Our ref: 22HNC\_1174

Your ref: SPI20211117000198

**RE: Request for Additional Information Response — Proposed Residential Subdivision – Callala Bay Expansion Area**

Figure 1: Egress options and estimated travel times (Google Maps)

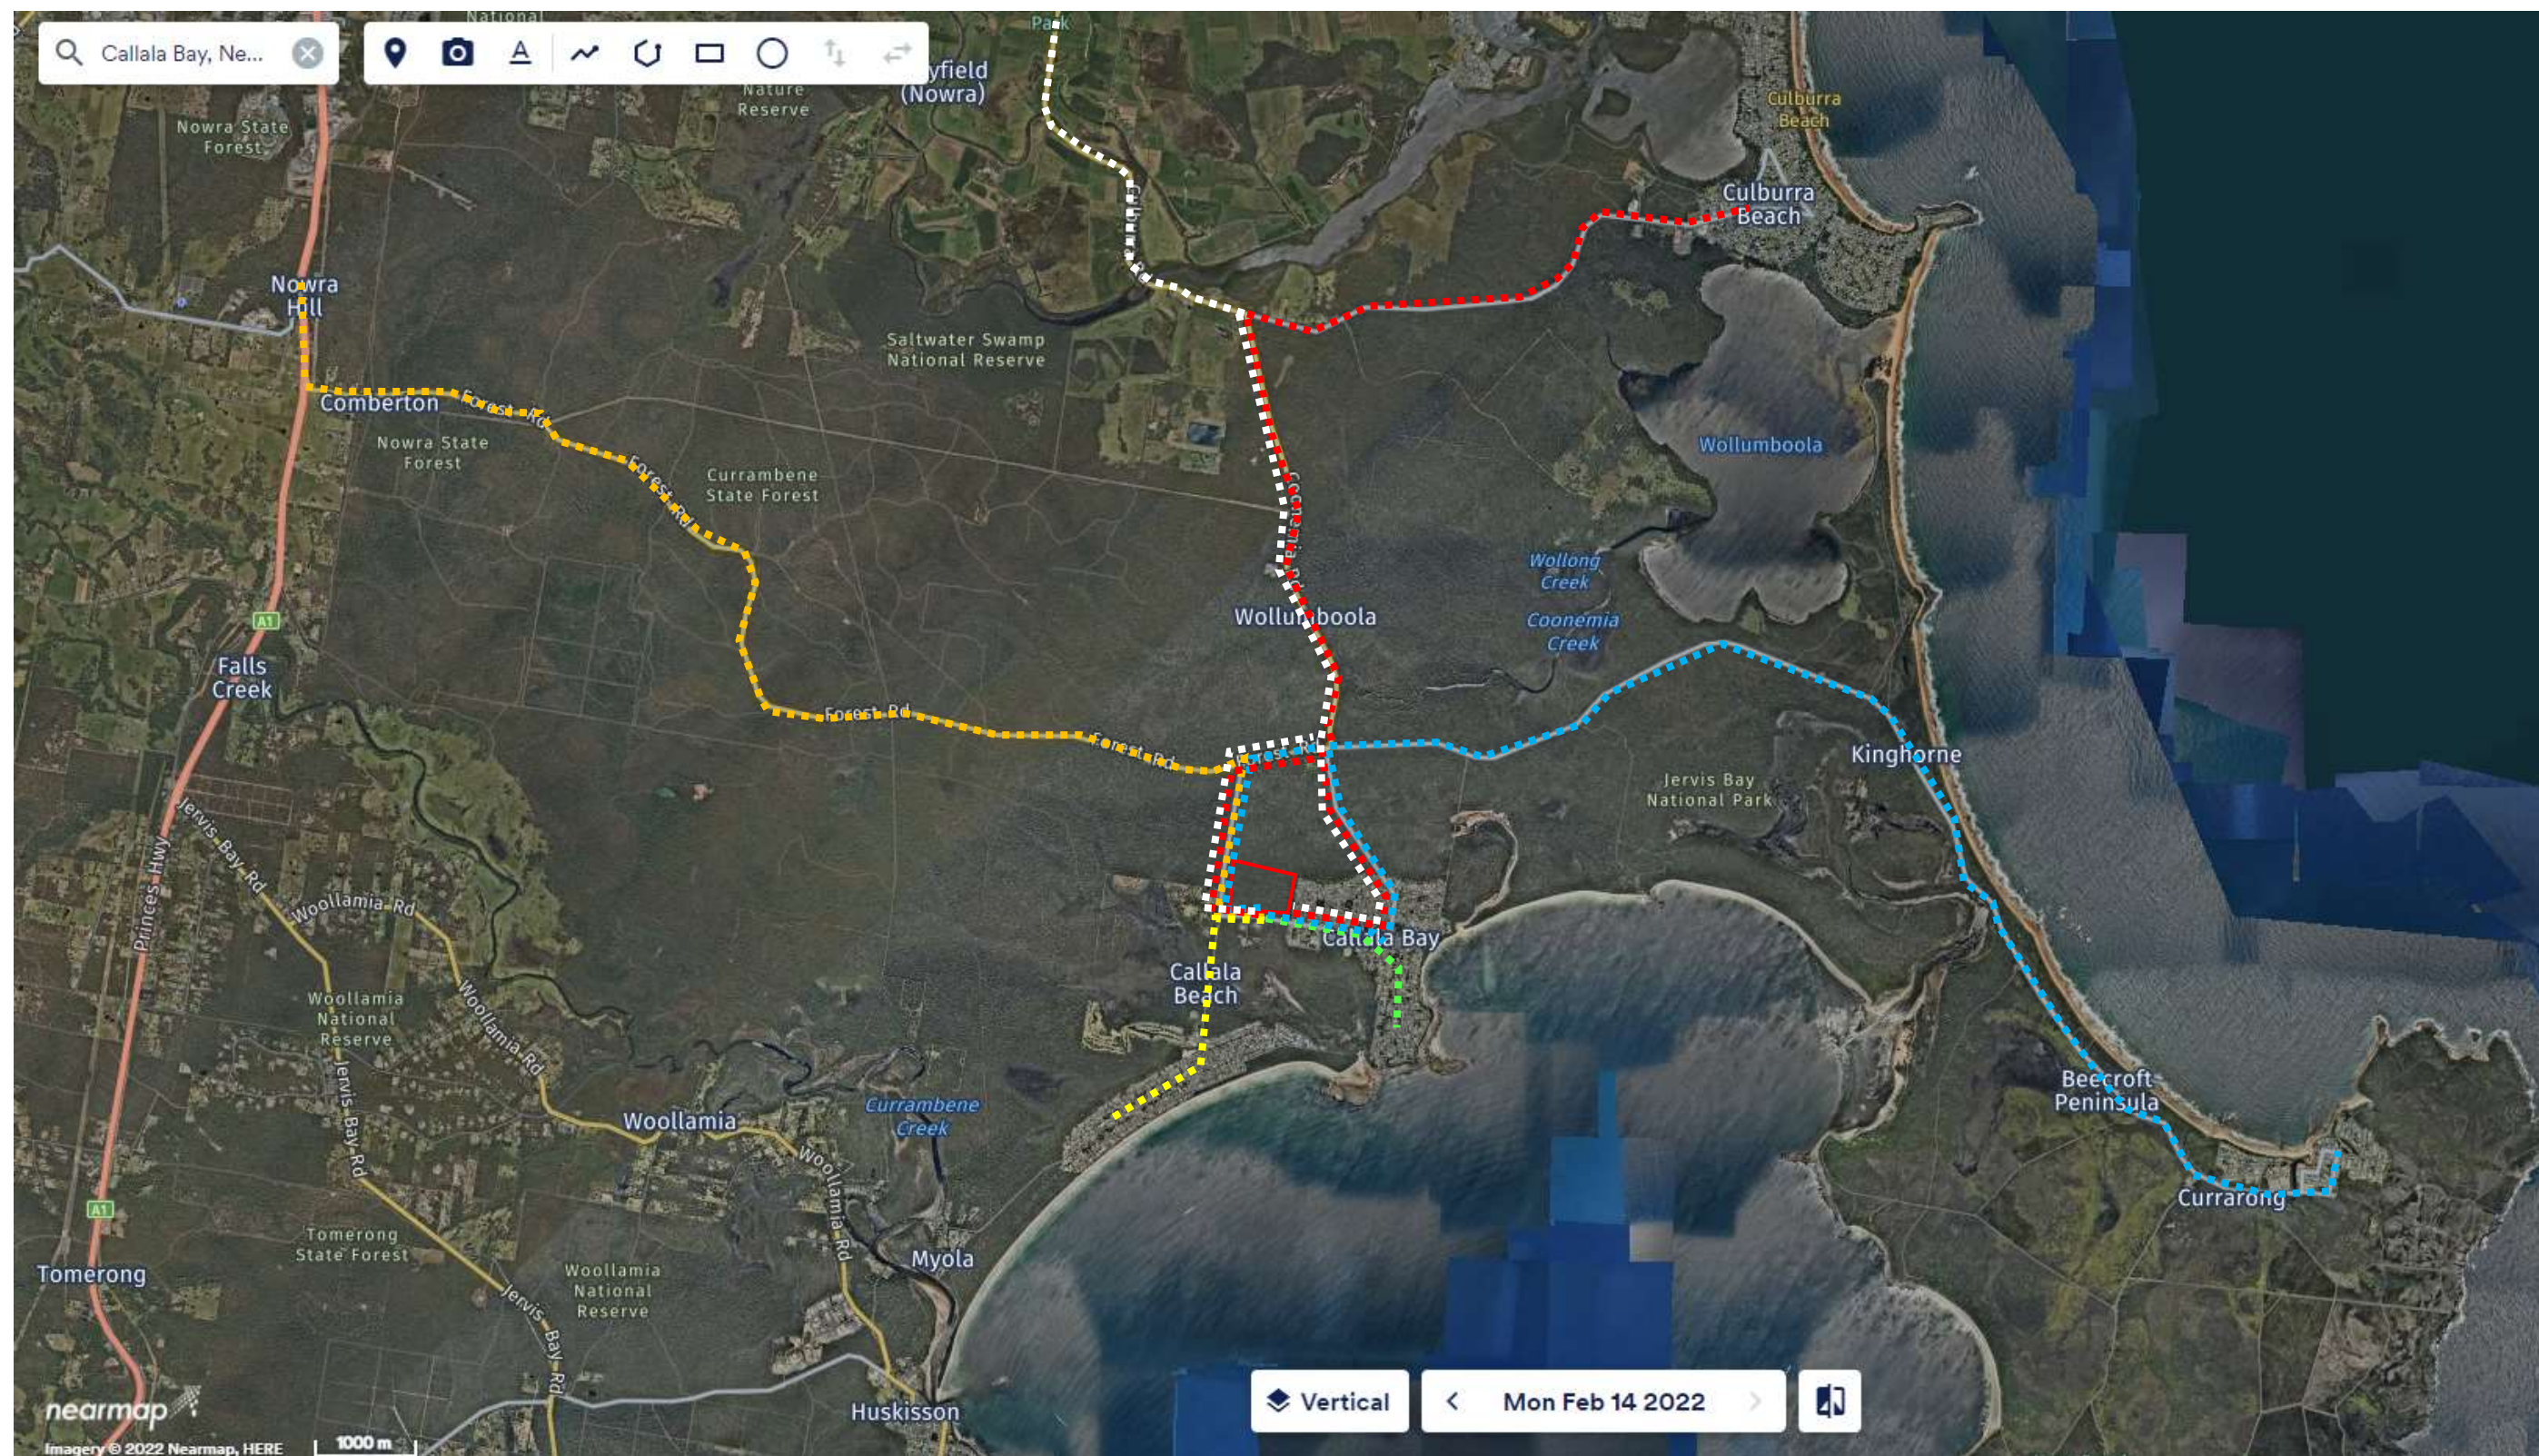
- the proposed and existing road network to deal with evacuating residents and responding emergency services;
- the location of key access routes and direction of travel
- the potential for the development to be isolated in the event of a bush fire.
- an assessment of any existing or potential community refuge buildings and/or areas both within the planning proposal site and within the existing village.
- consideration should be given to additional eastward egress from the pp site into the existing village area.

Figure 1 shows the key egress routes available to destinations outside of Callala Bay Village that can meet an outdoor NSP standard. Notably these landscape wide routes go in all four cardinal directions; north, east, south and west. This provides viable early evacuation destinations regardless of the direction of the bushfire threat.

There are no fire pathways evident from fire history, ignition risks or terrain/hazard analysis that suggest the Proposal Site poses an unusual bushfire risk. The four major egress directions (Figure 1) are a significant factor in reducing the risk of isolation.

Figure 1: Existing Dwelling Zones

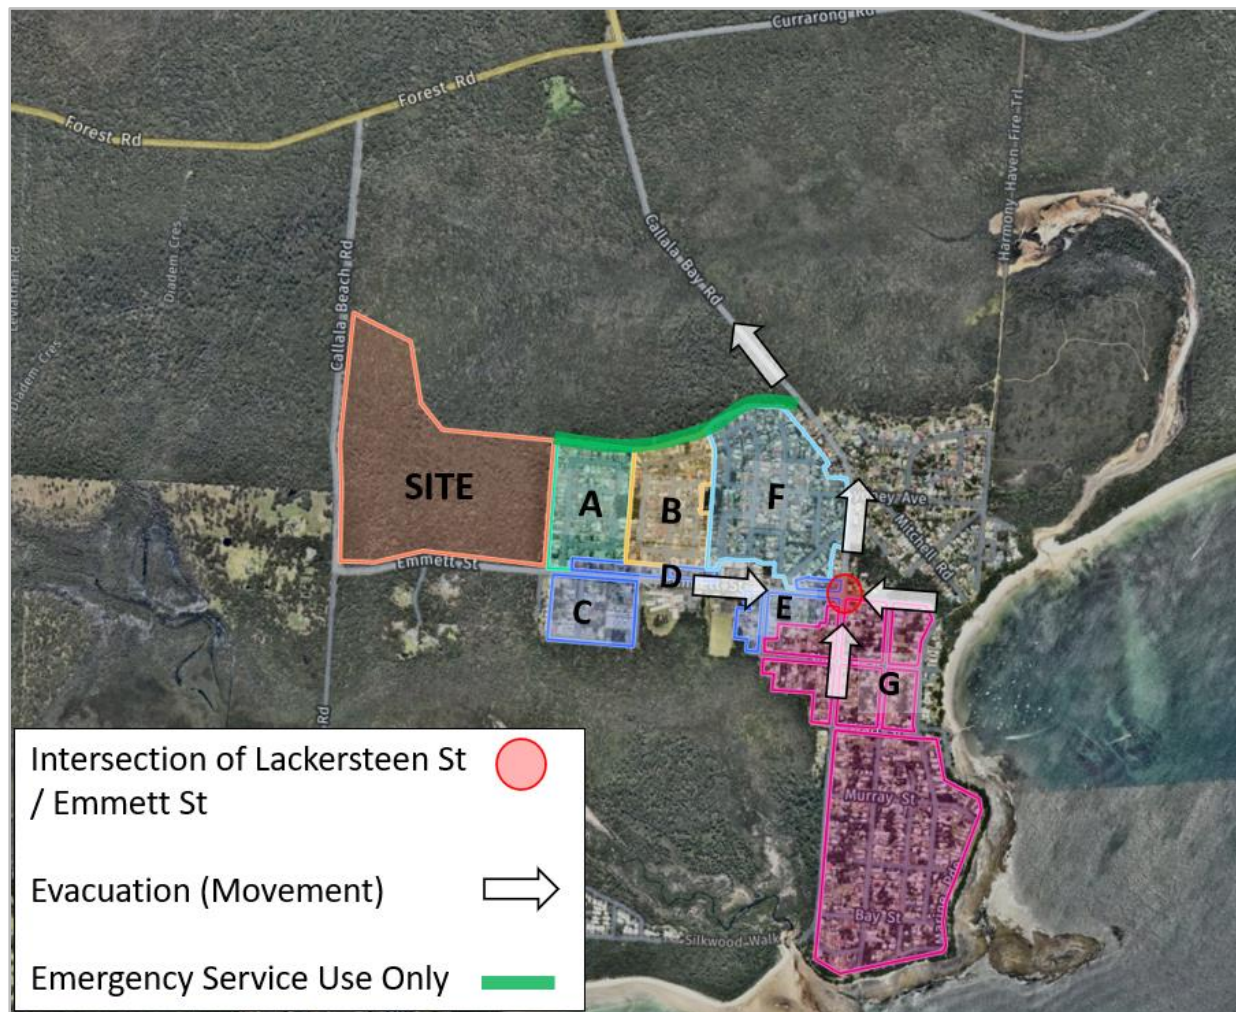
- All evacuation traffic will be eastward along Emmet Street
- Emmet Street is the only east - west road through the village and congestion issues are already apparent without the additional traffic generation
- Emmet Street, along the southern interface of the planning proposal area, is impacted by forested vegetation
- It is unclear where within the existing village evacuating residents would take refuge. Existing public building and places Callala Bay are sited on the southern side of the village with potential impact from bush fire within the southern hazard area.
- Further information should be provided to demonstrate the two roads on either side of proposed C3 zoned land will not directly adjoin retained forested vegetation.

The study area has been broken into the areas shown within Figure 1 in order to determine the movements at the intersections.

- **Trip Generation** – Based on the number of dwellings from the south of Lackersteen Street / Emmett Street intersection (Area G), there will be about 500 trips travelling northbound from the south and some 20 trips travelling northbound from the east of the intersection. It is expected that the 20 trips will be generated from dwellings along the east of the intersection.
